**DISPOSAL OF CHEMICAL AGENTS  
AND MUNITIONS STORED AT  
ANNISTON ARMY DEPOT  
ANNISTON, ALABAMA, FINAL PHASE I  
ENVIRONMENTAL REPORT**

FINAL PHASE I  
ENVIRONMENTAL REPORT

## 2. RESPONSE TO THE PHASE I REVIEWER'S COMMENTS

Fig. 1. Seismic zone map of conterminous United States and locations of Anniston Army Depot (ANAD) and Tooele Army Depot (TEAD). *Source:* Modified after ICBO (International Conference of Building Officials), *Uniform Building Code*, Whittier, Calif., 1988.

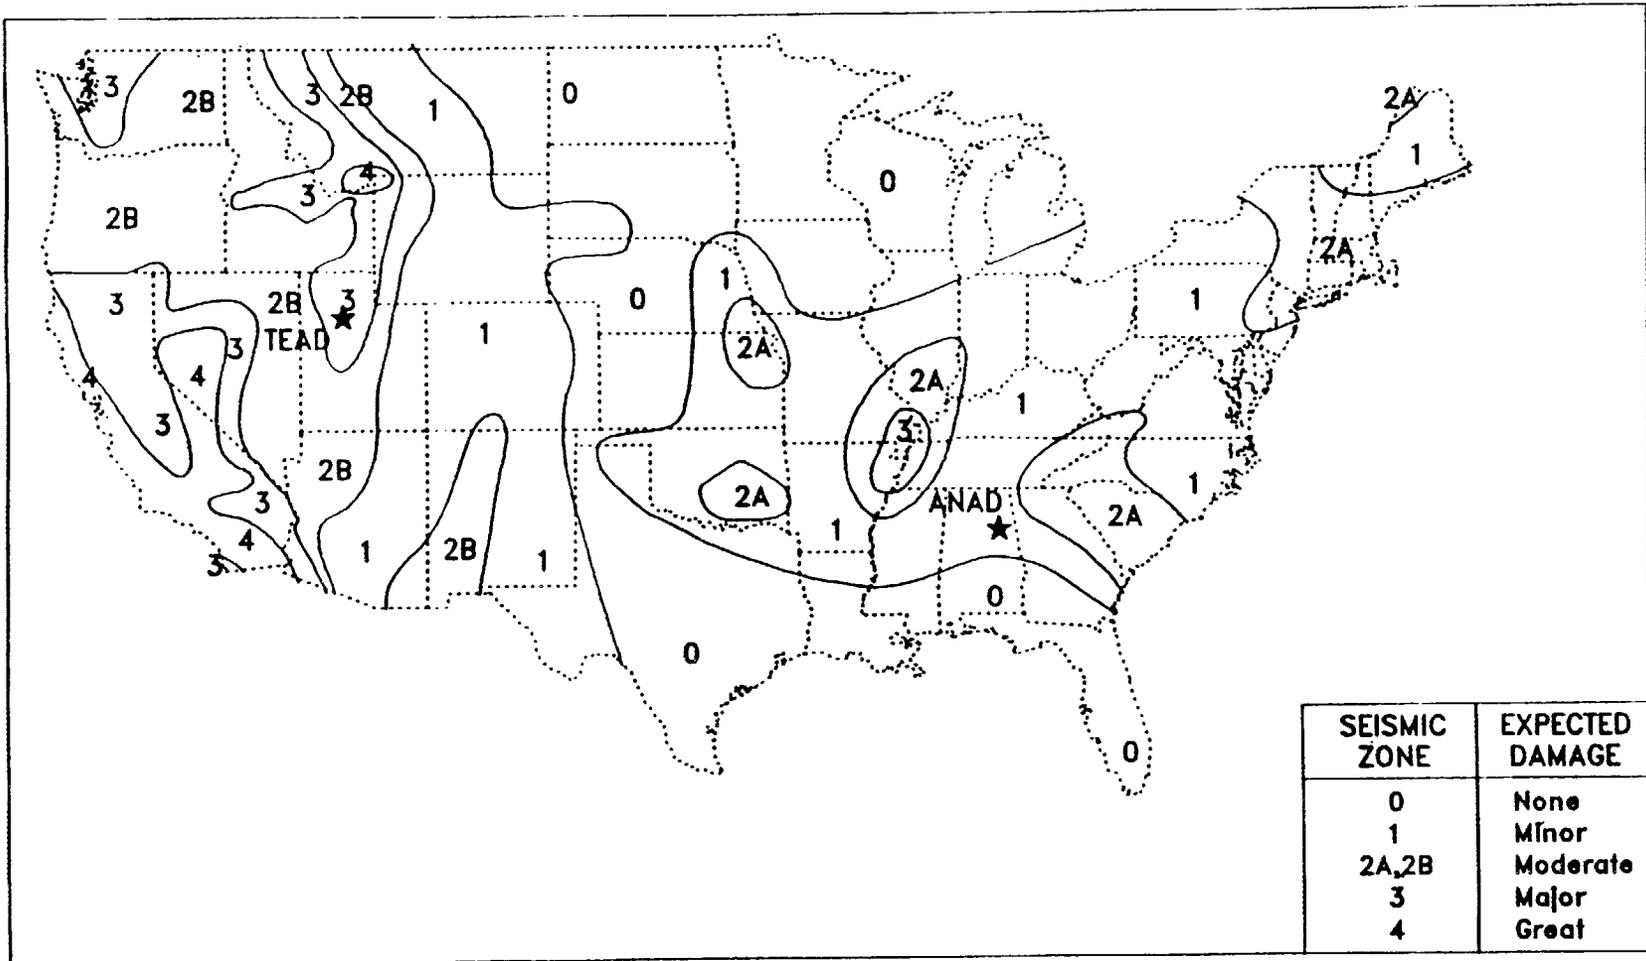
B. No geologic or engineering log to bedrock is given, and the reader must accept on faith that strata underlying 18 m are competent. The phase I report does not indicate overburden thickness. The phase I report does not provide such data as earthquake catalogs and seismicity maps. The seismicity section of the phase I report is current but incomplete. Current seismotectonic issues are not discussed, seismicity maps are not included, locations of known faults are not shown, depths of overburden are not given, and most references are absent (Krummel et al. 1990, Sect. 4.3, p. 11). This information will be developed for inclusion in the site-specific EIS for disposal of ANAD's stockpile of chemical agents and munitions; current (draft) versions of key components of this information are presented below.

Figures 1 and 2 are seismic zone maps of the United States based on International Conference of Building Officials (1988) and Federal Emergency Management Agency [(FEMA) 1988] data, respectively. Figure 1 shows that ANAD is in Seismic Zone 1 (a zone having potential for minor earthquake damage). In comparison, Tooele Army Depot (TEAD) is in Seismic Zone 3 (a zone having potential for major earthquake damage). Figure 2 shows that ANAD is located in an area where an effective peak ground acceleration of slightly greater than 0.05 g would have a 10% probability of exceedance at least once in 50 years.
